TRANSPORTATION MEMORANDUM

Flying Horse North Filing 9
El Paso County, Colorado
PCD File No. ~~PUDSP263~~
SF2625

August 2026

This traffic impact study has been revised to address County review comments made to the June 2026 version regarding the addition of missing evaluation elements from Section B.2.4.D of the County's ECM.

Figure 6
TOTAL TRAFFIC - YEAR 2028
Volumes & Intersection Geometry
AM / PM Peak Traffic Hour
(ADT) : Average Daily Traffic

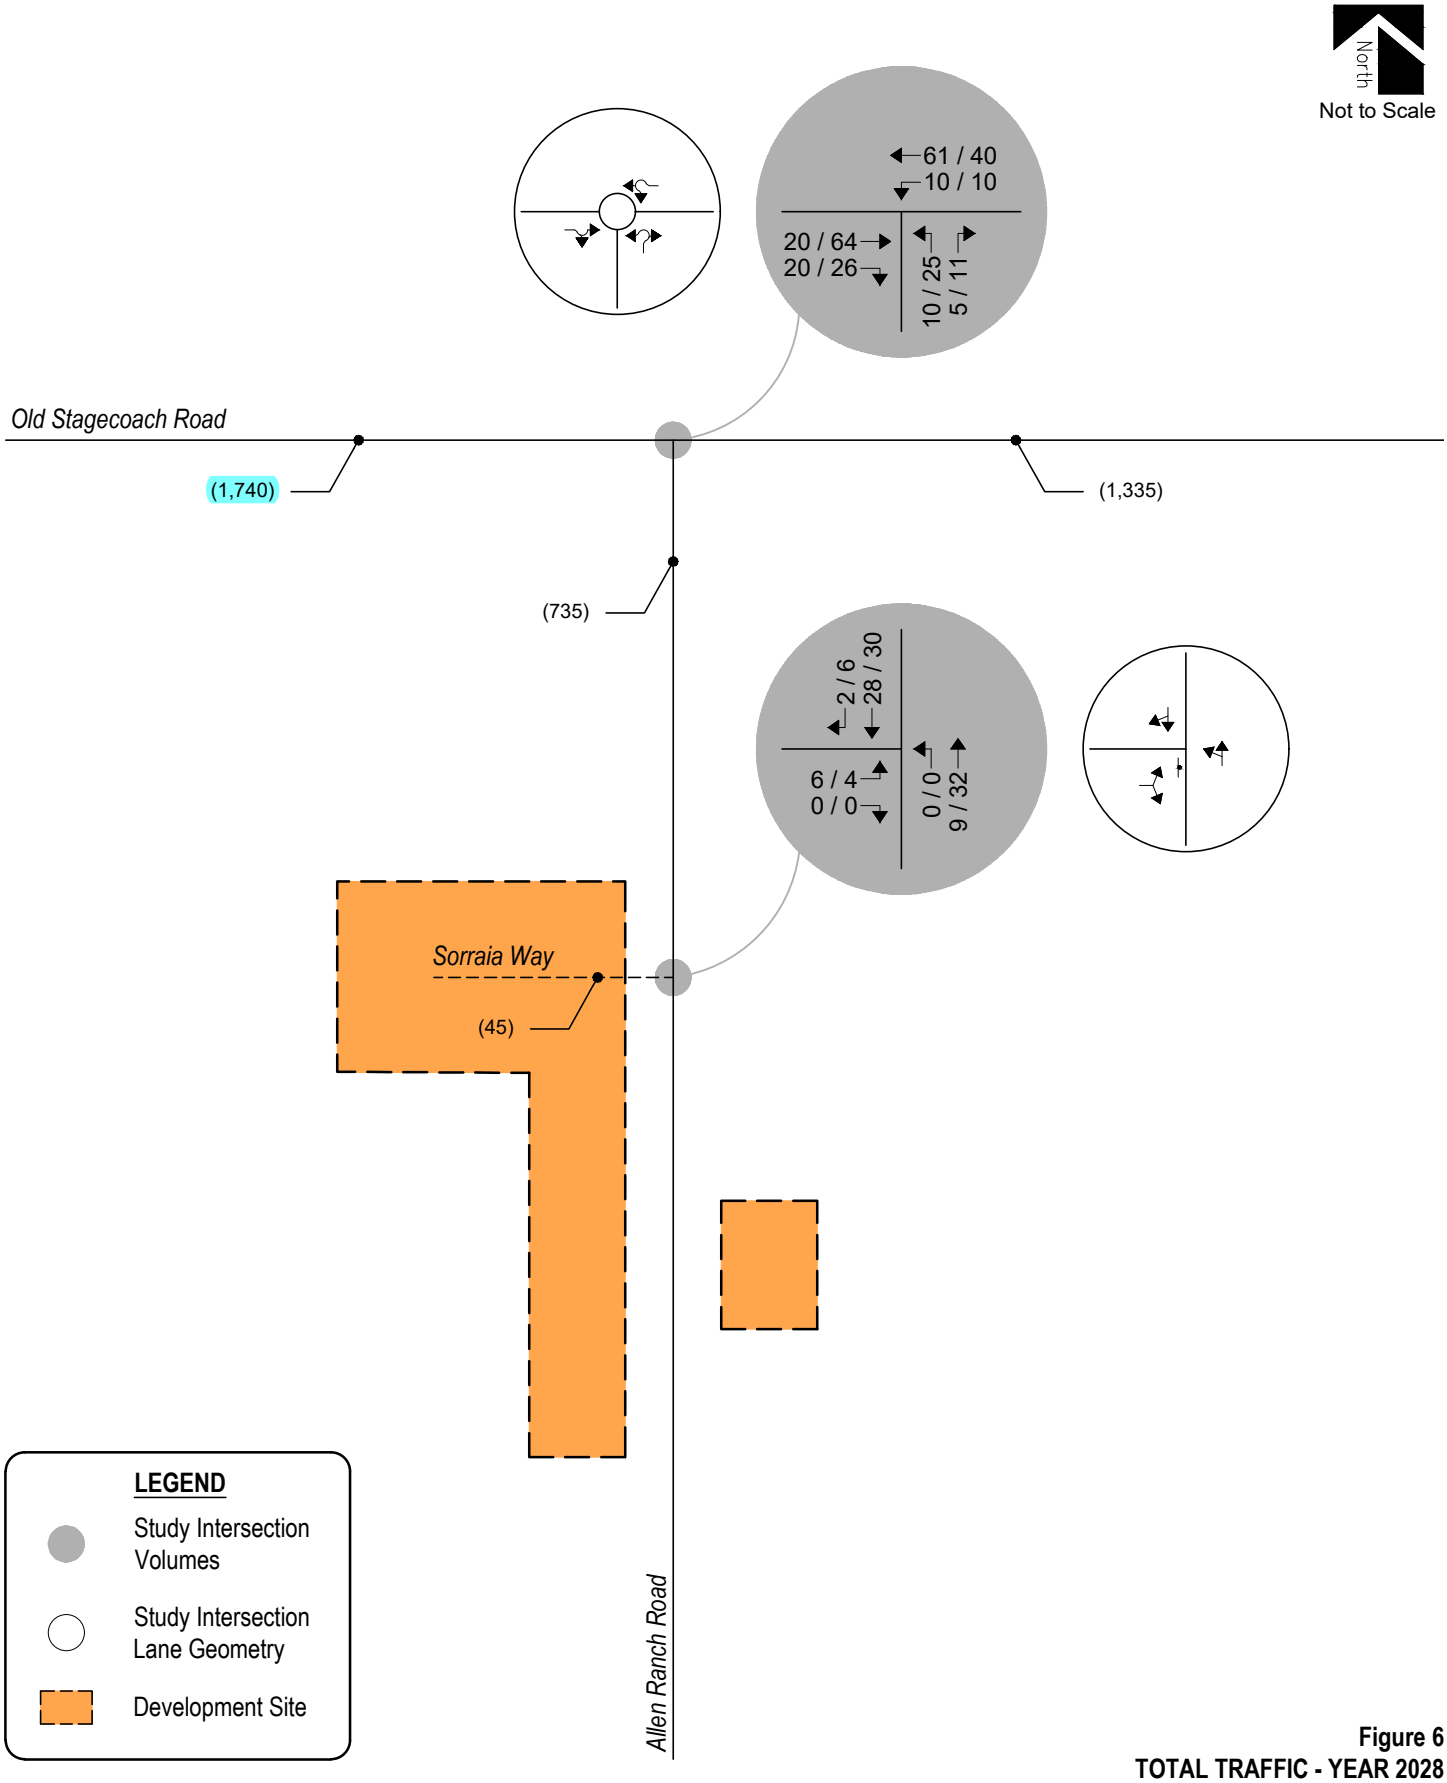
Please include any safety issues, speed limit concerns or other general discussion about why the section does not need to be improved to the major collector standard. Please include if the pavement thickness is sufficient for the additional traffic. The intersections operate with LOS A, however there has been no discussion related specifically to the cross section.

FLYING HORSE NORTH FILING 9
Conceptual Sight Distance Exhibit

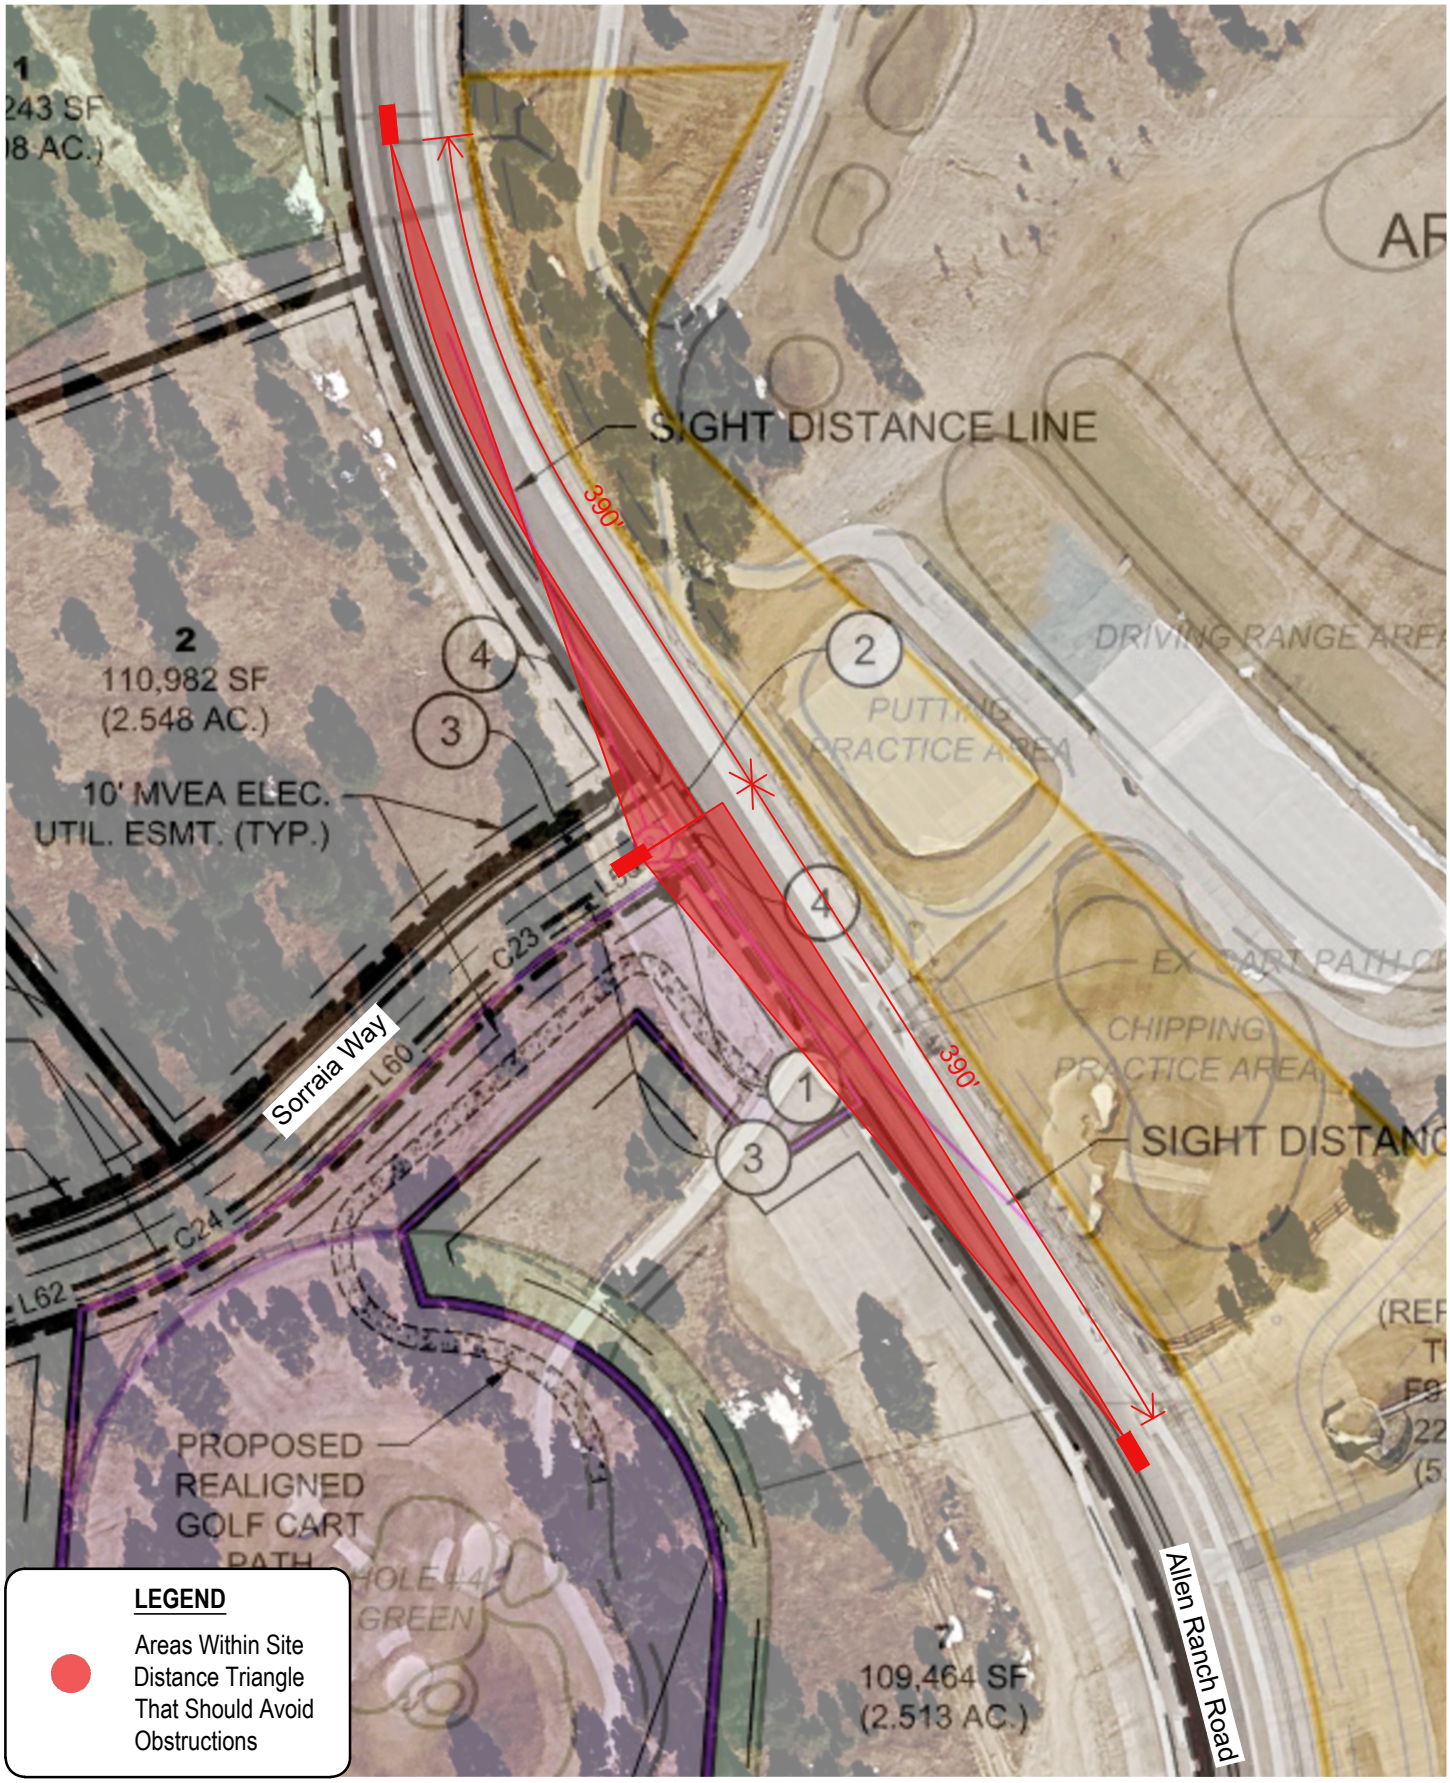
The vertical profile of the road must also be considered when evaluating intersection sight distance. The conceptual sight-distance exhibit does not address vertical elements. Please coordinate with the project civil engineer to provide this information.

The vertical profile of the road must also be considered when evaluating intersection sight distance. The conceptual sight-distance exhibit does not address vertical elements. Please coordinate with the project civil engineer to provide this information.
